**Errata 5 to TS 102 796 V1.4.1 and
Errata 2 to TS 102 796 V1.5.1**

2020-10-14

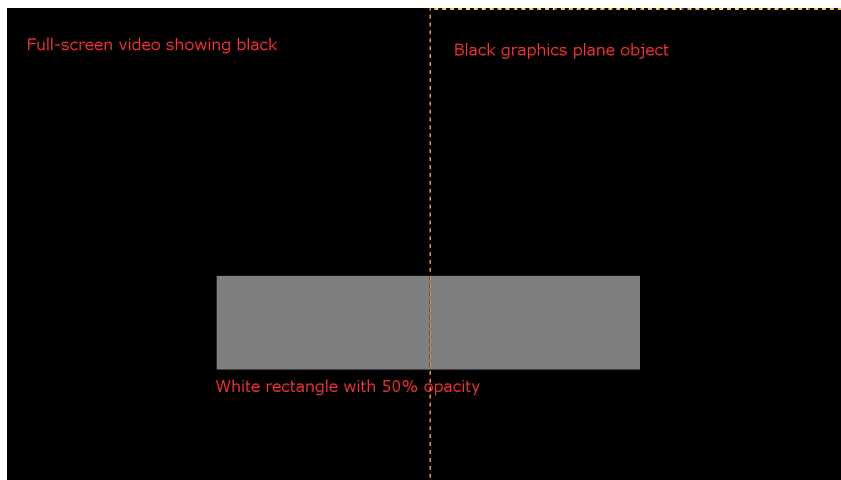
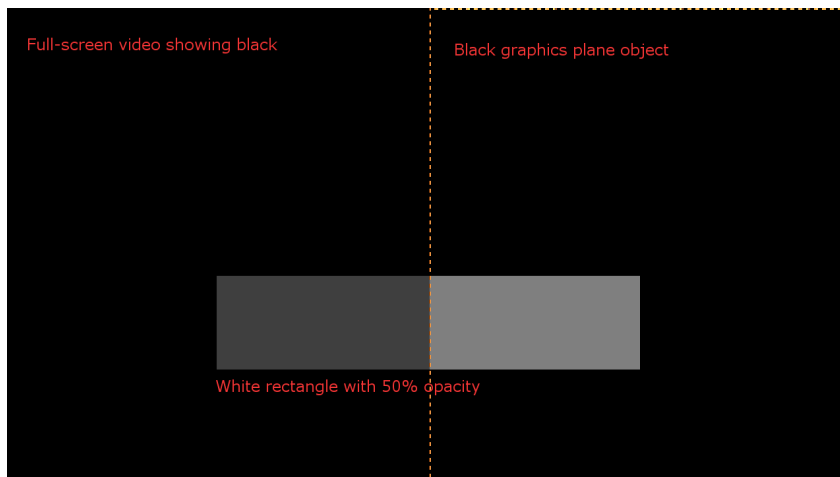
NOTE 2: The compositing equations defined in CSS produce pixels represented in “alpha pre-multiplied form”, whereby the R, G and B colour values of the pixel are each “pre-multiplied” by the pixel’s resulting alpha value. For example, a white pixel with 50% opacity on a 32-bit graphics plane would be represented by pixel values of

EXAMPLE 1: A video is playing full screen and an opaque image covers the right-hand half of the picture such that the displayed colours match. When a semi-transparent graphics-plane element is placed over both the video and the image, the colour also matches.

The following figure illustrates this with black video and an opaque black image:

4.11.5 InitMediaSynchroniser

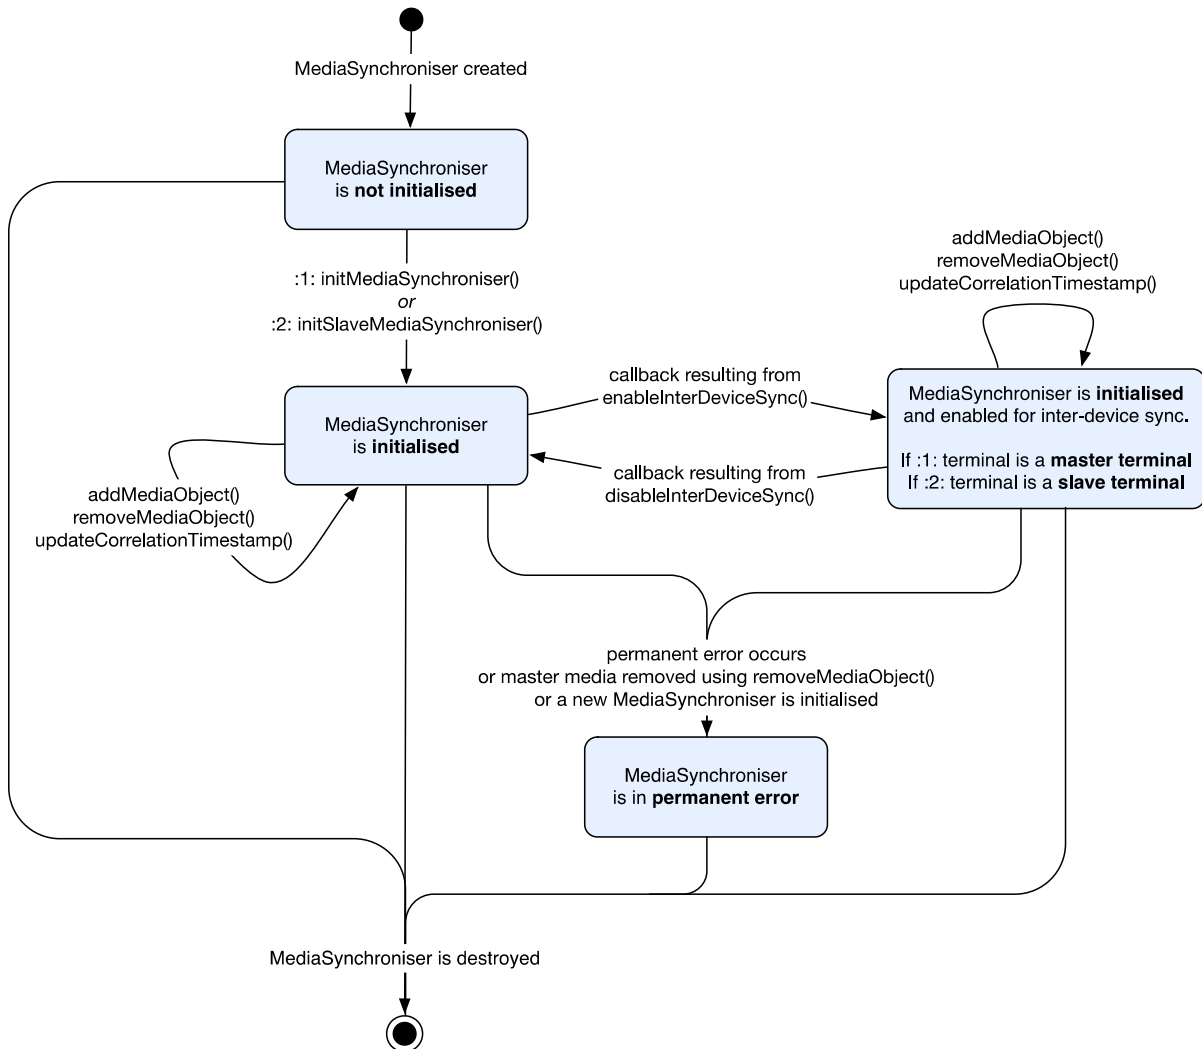
In clause 13.11.3, “If the timeline is not yet available (see clause 9.7.3) then the value returned shall be NaN. In all other situations,” is added as shown underlined.

In clause 13.3.1, the figure is replaced with the following:

Figure M.1: Example of alternate audio track for a single broadcast TV programme

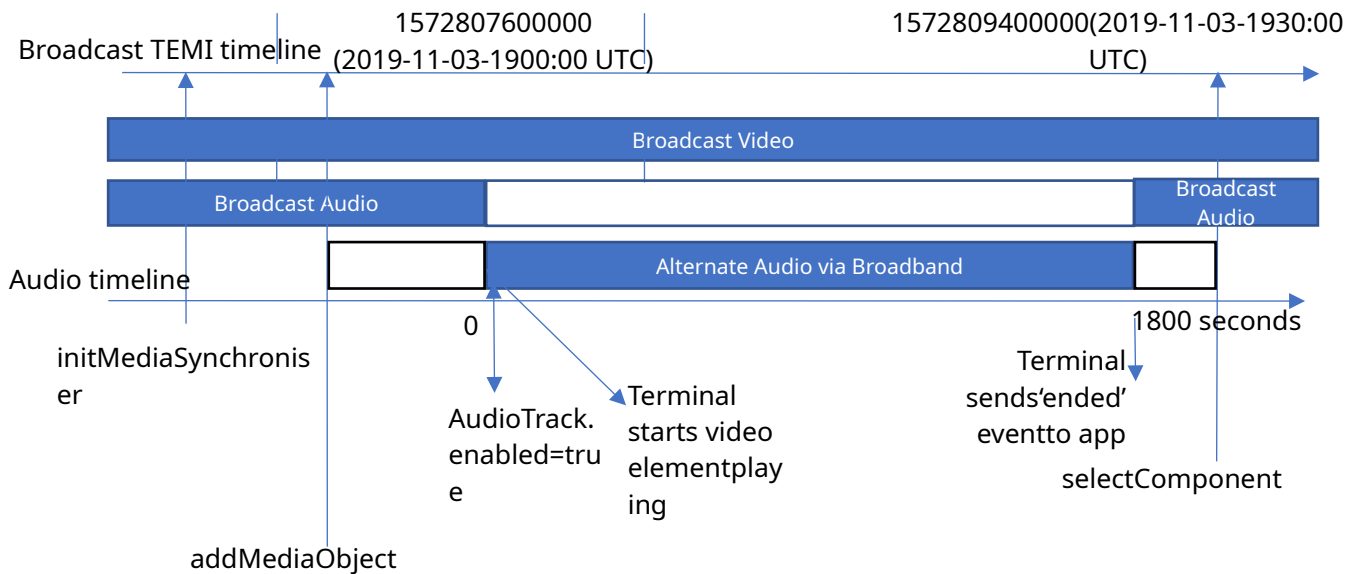
Figure M.1 illustrates the example of a single broadcast TV programme that has an alternate audio track that is available via broadband. Examples uses for alternate audio tracks include accessibility (audio description for the partly sighted, clean audio for the hard of hearing) as well as additional

Figure M.2: Example of alternate audio track for a broadcast TV service

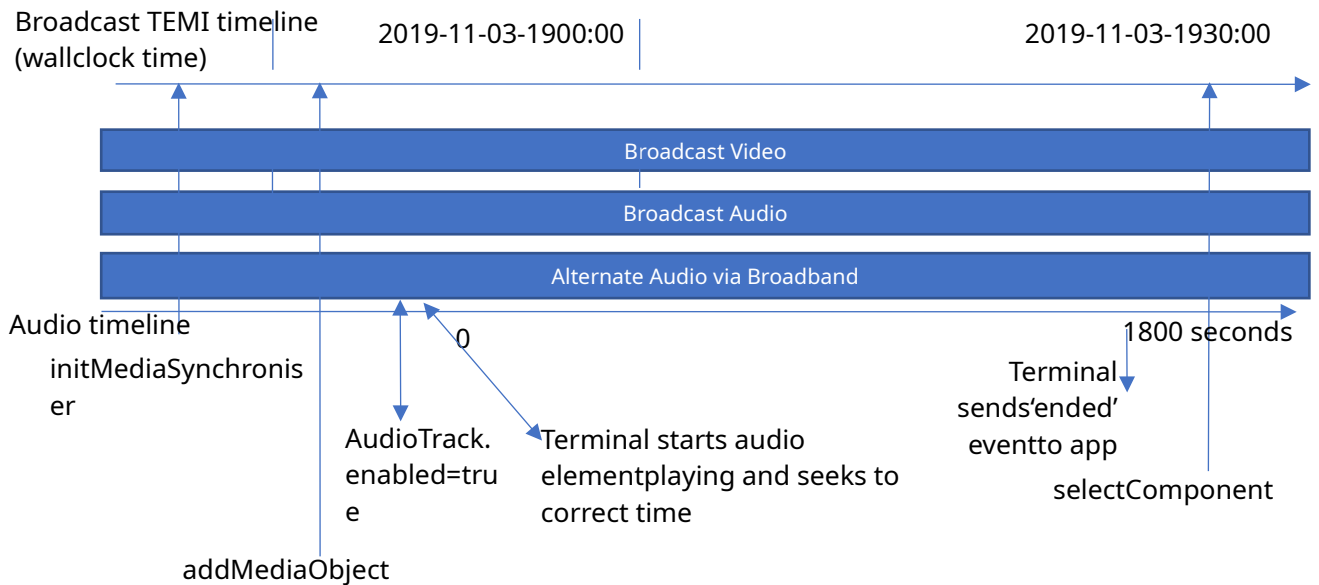
Figure M.2 illustrates the example of a broadcast TV service that has an alternate audio track that is available via broadband. Examples uses for alternate audio tracks include accessibility (audio description for the partly sighted, clean audio for the hard of hearing) as well as additional languages.

In contrast to clause M.1 and figure M.1, the alternate audio track is distributed as a live DASH stream. The steps involved are as follows;
